REVISED RESPONSE TO REQUEST FOR ADDITIONAL INFORMATION

APR1400 Design Certification

Docket No. 52-046

RAI No.: 235-8275
SRP Section: 12.03-12.04 - Radiation Protection Design Features
Application Section: SRP 12.3-12.4
Date of RAI Issue: 10/07/2015

Figure 1 Minimum Water Depth of the RM (at the Up-stop)

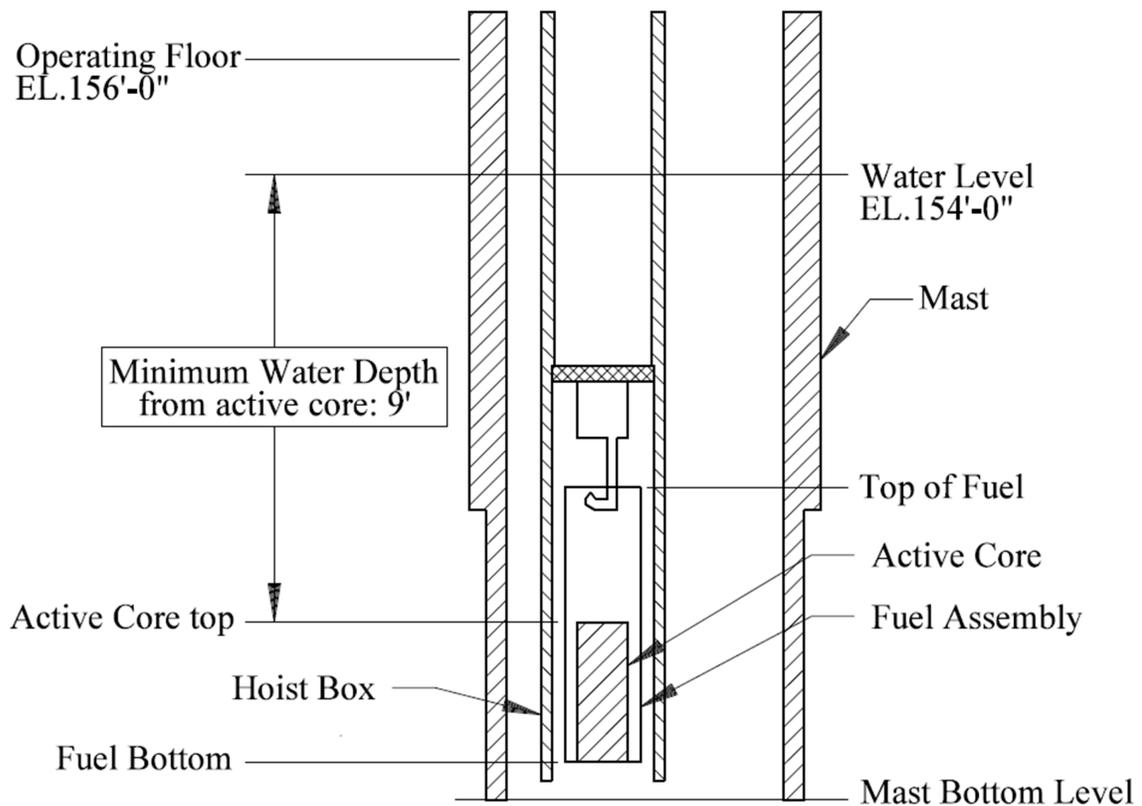
While the applicant references ANSI/ANS-57.1-1992, and provides spent fuel dose information in FSAR Figures 12.2-1 and 12.2-2 the applicant provides no information indicating what the maximum lift height of a fuel assembly in the refueling pool and spent fuel pool would be in order to maintain the 2.5 mrem/hour criteria for an operator on the refueling platform, considering the maximum fuel assembly being transferred at the earliest time allowed by technical specifications. Please specify this lift height in the FSAR and ensure that there is appropriate height in the spent fuel pool and refueling pool to allow for the movement of fuel (for example, ensure that sufficient shielding can be provided over the raised fuel assembly while allowing clearance between the fuel and storage racks seated in the bottom of the spent fuel pool).

Mechanical stops in both the refueling machine and the spent fuel handling machine restrict withdrawal of the spent fuel assemblies as described in DCD Tier 2 section 9.1.4.3.

This results in the maintenance of a minimum water cover of 2.74 m (9 ft) over the active core region of the fuel assembly as shown in Figures 1, 2 and 3 when the lifted spent fuel assembly is at the mechanical stop. The resulting radiation level from the spent fuel is 2.5 mrem/hr or less in the work area when the shielding of the fuel handling equipment is taken into account. The SFP shielding has been designed for the maximum anticipated enrichment and burnup of the fuel assemblies.
